- **LOCKS—IGNITION—DEALERSHIP CUT KEYS DO NOT WORK IN IGNITION—ROTUNDA KEY BLANKS SOLD PRIOR TO 3/1/91**
- **IGNITION SWITCH—DEALERSHIP CUT KEYS DO NOT WORK IN IGNITION—ROTUNDA KEY BLANKS SOLD PRIOR TO 3/1/91**

**Article No.  
92-5-3**

**MERCURY:** 1991-1992 CAPRI

Figure 1 - Article 92-5-3

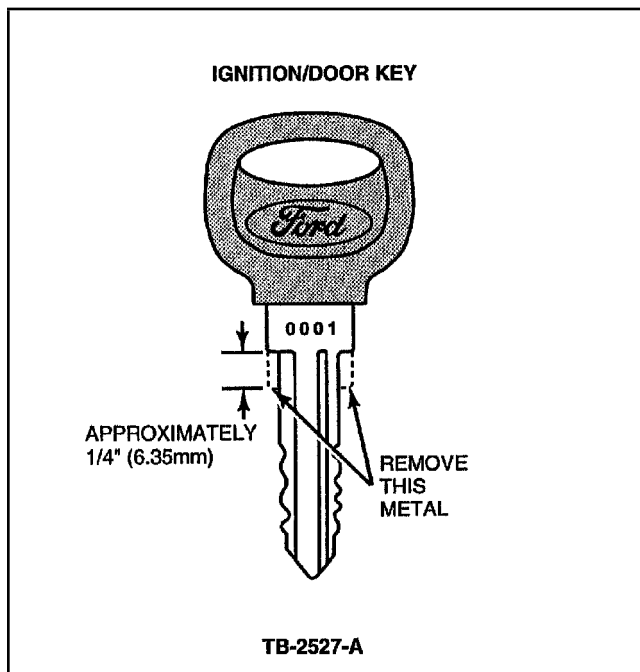
Some dealership-cut ignition keys may open the doors but not engage the ignition, thus preventing the car from starting. This is caused by a shoulder on the blade of the key blank #011-00155, Figure 1.

Remove the excess metal from the key blade, as shown in Figure 1. Use a file or key duplicator. To order key blanks, call the Rotunda Hotline: 1-800-762-6181 (Rotunda Dealership Supplies - Option 2).
